Improvements to consider for jitter measurements

Comments #211, #212, #213, #64

Adee Ran, Cisco

Table 179–7—Summary of transmitter specifications at TP2 *(continued)*

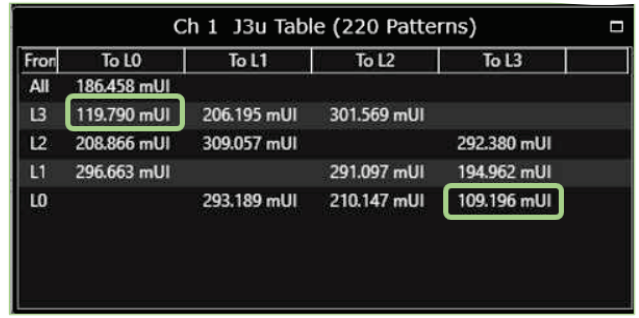
The “composite result” mentioned needs to be addressed.

$J3U_{03}$ is formed from a composite of targeted L3->0 and L0->3 uncorrelated edge jitter. The composite result has some questions but the the individual values are solid.
Similarly EOJ_{03} is formed from a composite of targeted L3->0 and L0->3 Even/Odd jitter elements. The composite value here is WIP, but the individual L3->0 and L0->3 values are correct.
